Product / Process Change Notification (PCN)

PCN #: PCN_conDSUB_20221214
Affected Series: WR-DSUB ; 6180xx25311
PCN Date: September 14, 2022
Effective Date: December 14, 2022

Detail of Change:

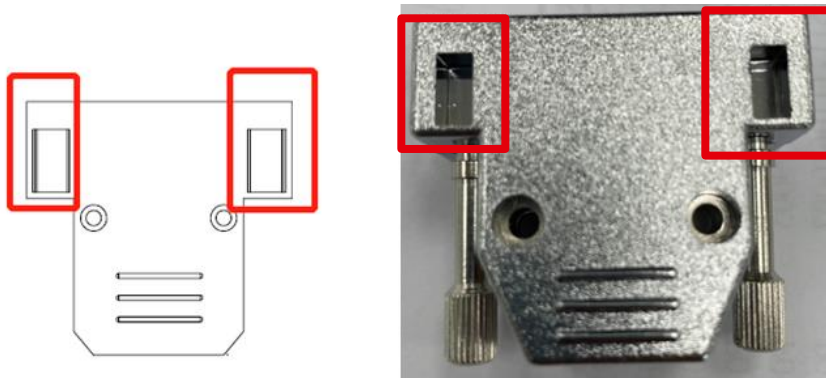
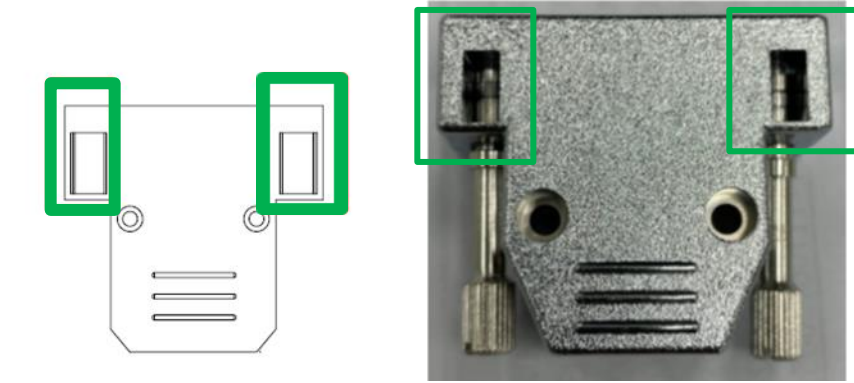
In order to enhance the product reliability, Würth Elektronik will modify the design of the plastic molded hood. This change has no influence on the functionality of the product, and will allow to ease the plating process. All products with date code 2022-07-18 or later, will be affected by this change. There will be no change in fit, function, quality or reliability of the product.

The openings on the side of the hood above the screws are closed.

The openings are through hole type.
